Mobile Intel® 965 Express Chipset Family Graphics Memory Controller Hub (G)MCH

Specification Update

Revision 008

Section 6.3.1 Figure 10 SDVO Conceptual Block Diagram

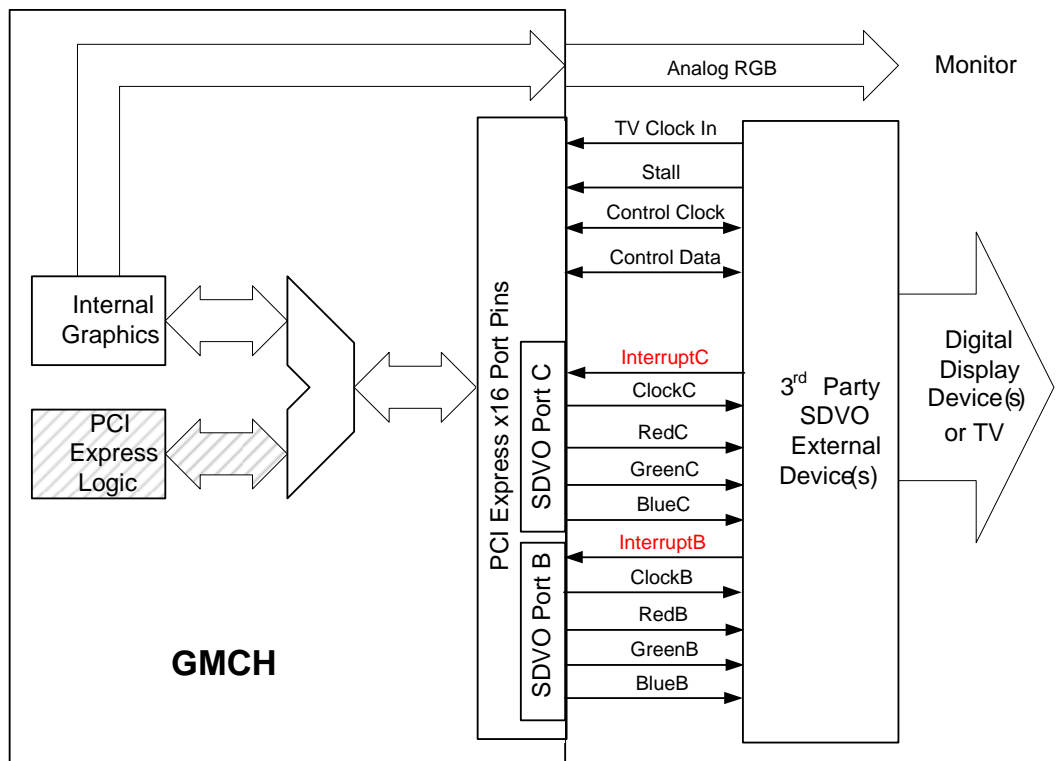
2. SDVOB_INT and SDVOC_INT Signal Naming

Changes are in **RED** font.
